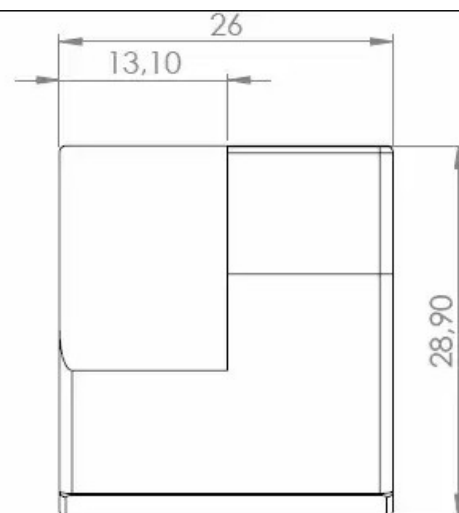
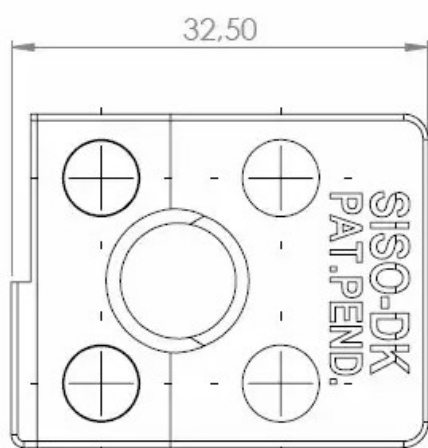
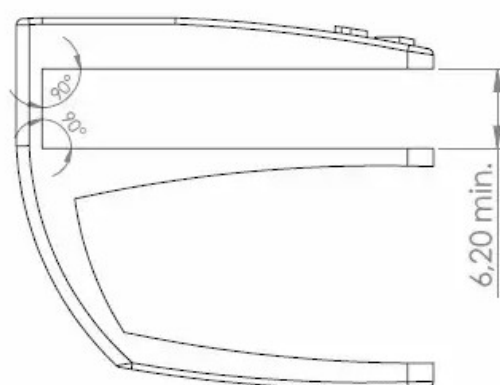
Changed from 6,00 mm. to 6,20 mm. 23-04-2012

Screws needed - not on drawing!!
One side shown
